SonTek Technical Notes

SonTek SL1500-3G and SL3000-3G Cell Locations (Firmware v3.0 versus previous versions)

On June 6, 2018, SonTek released firmware v3.0. Among many improvements and bug fixes, one aspect that was changed was the cell location placement. It was discovered that pre-v3.0 cell locations were reported incorrectly by the software/firmware – namely, they were too close to the system by 1 cell length. It is important to note that the fix in the cell locations does not affect the actual physical location of the acoustic pulses; it only pertains to how the firmware and software report where those locations are.

Zooming in on the Flow configuration chart, you can see the shift in the Multi-cell locations below.

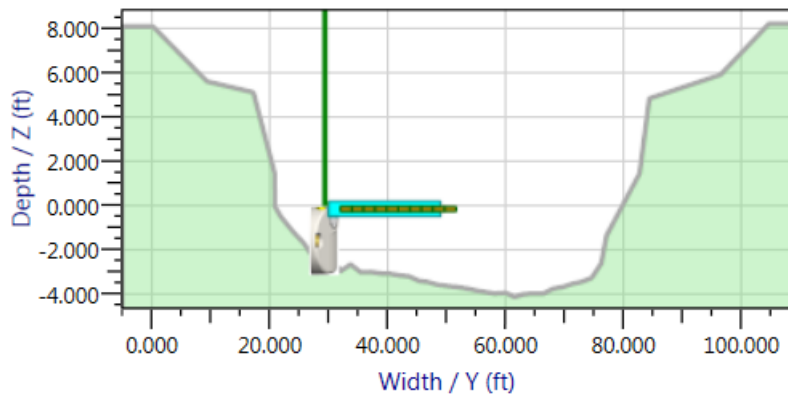
Older files that have not been modified via the Recalculate Flow function will load as normal in software v3.0. However, if you right click on the file to open the system configuration view you may see a warning indicator next to the Velocity Configuration section and a shift in the cell locations in the Flow Configuration section.

You can leave this file as is or you can correct the location of the IVC using the "Recalculate Flow" function. To correct the IVC location, click the "Recalculate Flow" button and navigate to the Flow configuration window. The "Integrated velocity cell begin" setting will be highlighted in red to indicate an error. Adjust this setting so that the IVC begin location is equal to or greater than the "Multi-cell begin" setting.

Below are how you will see the cell locations displayed in post- and pre-v3.0 firmware.

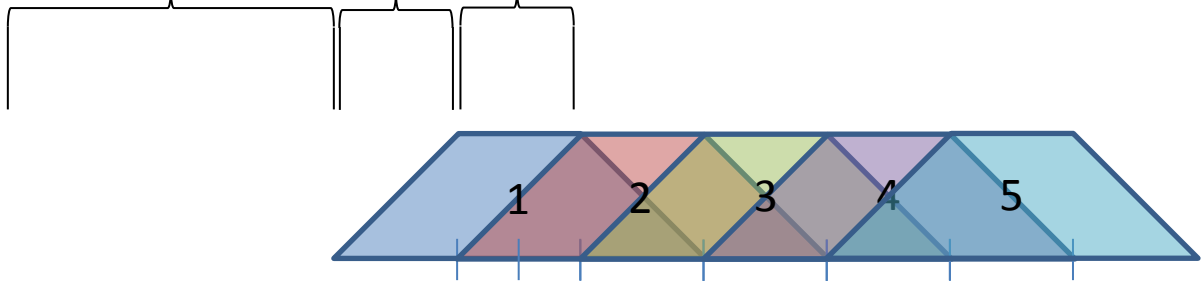
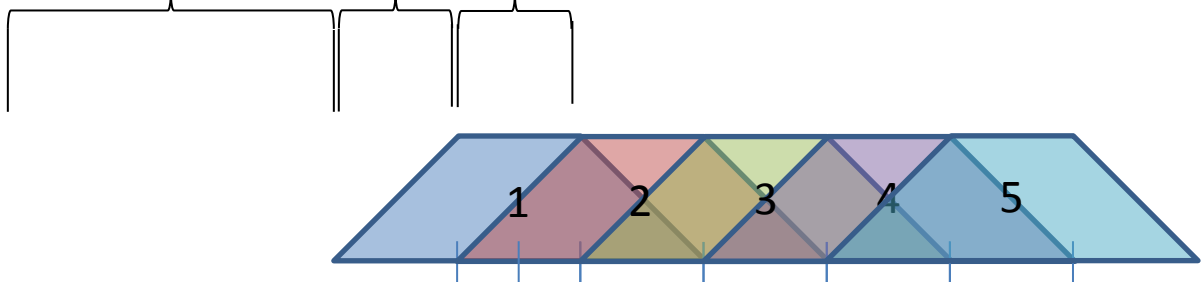
Start of 2nd Cell = Blanking Distance + 2*Cell Size = End of 1st Cell

Start of 2nd Cell = Blanking Distance + Cell Size = End of 1st Cell

Start of 1st Cell = Blanking Distance + Cell Size

Start of 1st Cell = Blanking Distance
